Detail 1

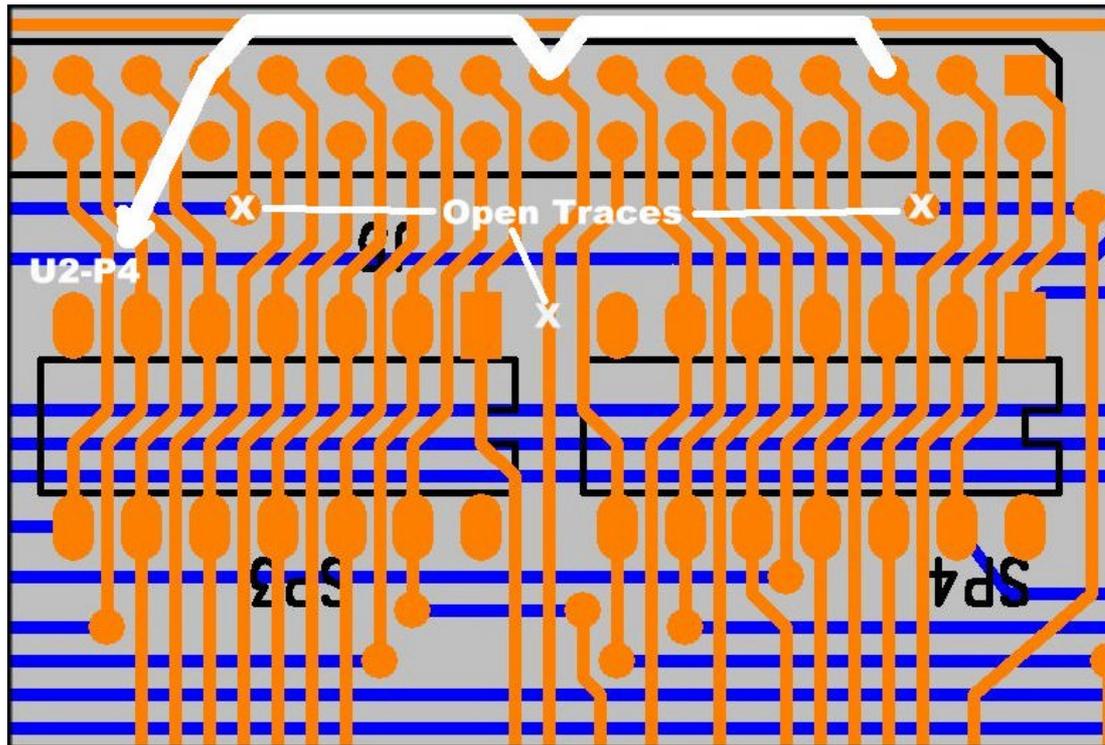
Open conductors in the three (3) places shown below.
Hand drill the vias only enough to open the trace and cut the trace on the top of the board.
This is the J5 connector.

Detail 2

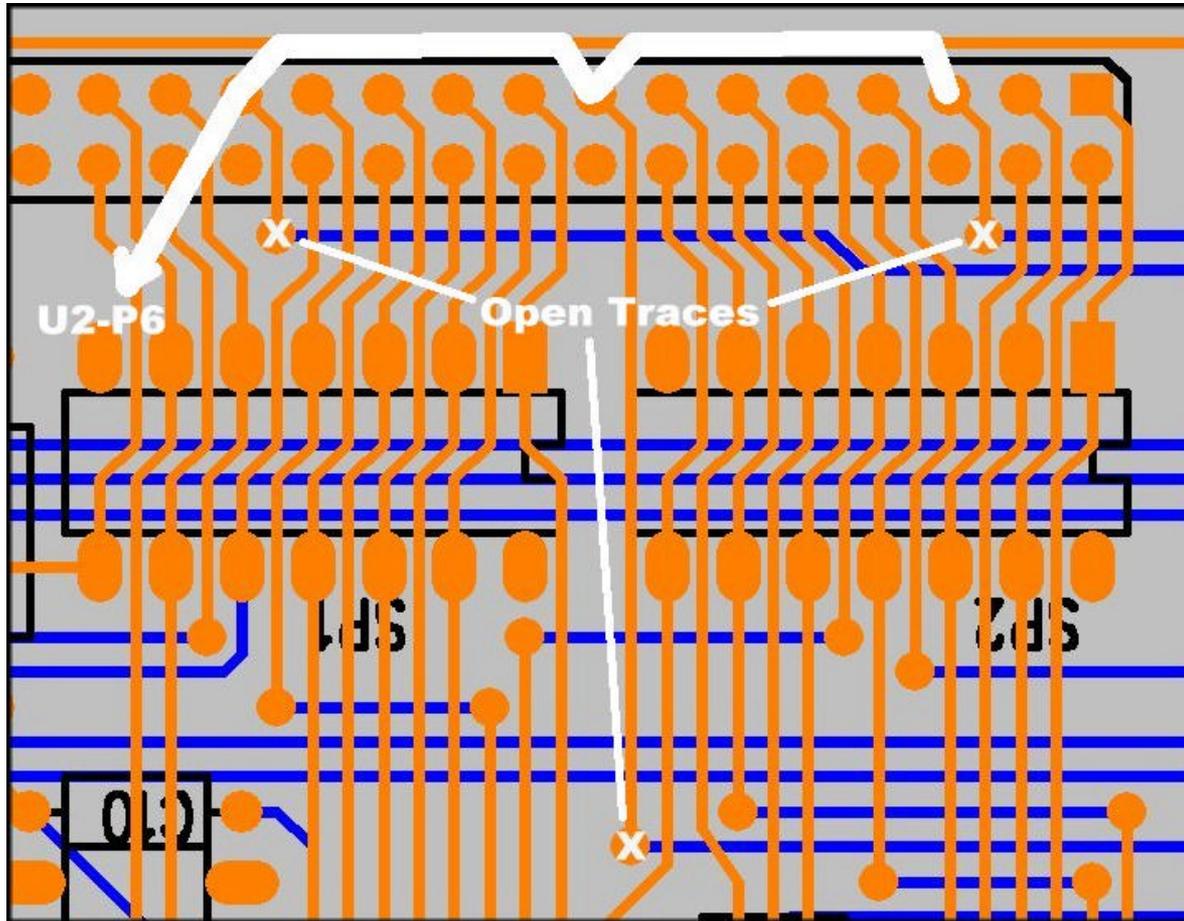
Open conductors in the three (3) places shown below.
Hand drill the vias only enough to open the trace.
This is the J4 connector.
